Access Compliance Report

Public Rights-of-Way

(Curb Ramps)

Intersection ID: N/A	Main Street: TYVOLA_RD	Cross Street: SPEER_BV	Location: NW
ADA ID: 0CF52946E882	Ramp Type: Perp	Initial Pass/Fail: Fail	Overall Compliance: No
		Severity Score: 12.5

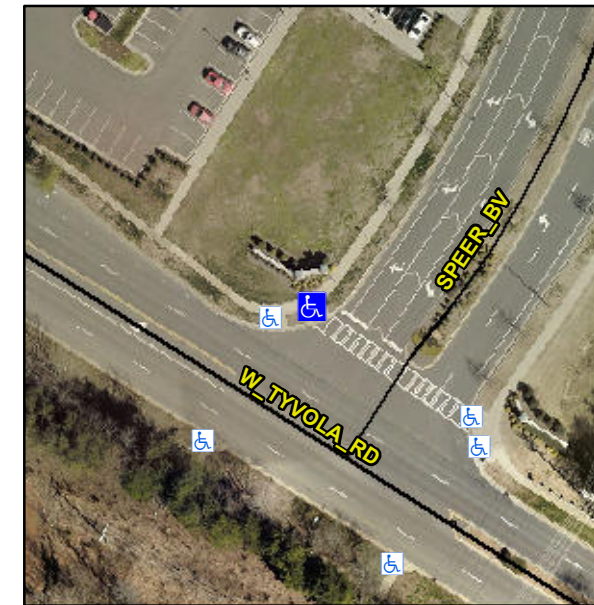
Not Found, R304.5.3

Compliance	Description	Data	Compliance	Description	Data
N/A	Ramp Length (in)	95.0	Yes	Ramp Slope (%)	6.8
Yes	Ramp Width (in)	58.0	No	Ramp XSlope (%)	5.6
N/A	Flare Type LT	N/A	N/A	Flare Type RT	N/A
N/A	Flare Slope LT (%)	N/A	N/A	Flare Slope RT (%)	N/A
N/A	Flare Traversable LT?	N/A	N/A	Flare Traversable RT?	N/A
N/A	Landing Length (in)	N/A	N/A	DWS Provided?	N/A
N/A	Landing Width (in)	N/A	N/A	DWS Contrast?	N/A
N/A	Landing Slope (%)	N/A	N/A	DWS Length (in)	N/A
N/A	Landing X Slope (%)	N/A	N/A	DWS Full Width?	N/A
N/A	Landing Curb? (Y/N)	N/A	N/A	DWS Offset (in)	N/A
N/A	Shared Landing?	N/A			
N/A	Gutter Ponding?	N/A	N/A	Gutter Slope (%)	N/A
N/A	Gutter Lip Ht (in)	N/A	N/A	Gutter X Slope (%)	N/A
N/A	Painted X Walk1?	Yes	N/A	Painted X Walk2?	N/A
	X Walk 1 Direction	To SE		X Walk 2 Direction	N/A
N/A	X Walk 1 Width (in)	113.0	N/A	X Walk 2 Width (in)	N/A
	X Walk 1 Slope (%)	5.0		X Walk 2 Slope (%)	N/A
	X Walk 1 X Slope (%)	5.3		X Walk 2 X Slope (%)	N/A

Remove & Replace Entire Ramp.
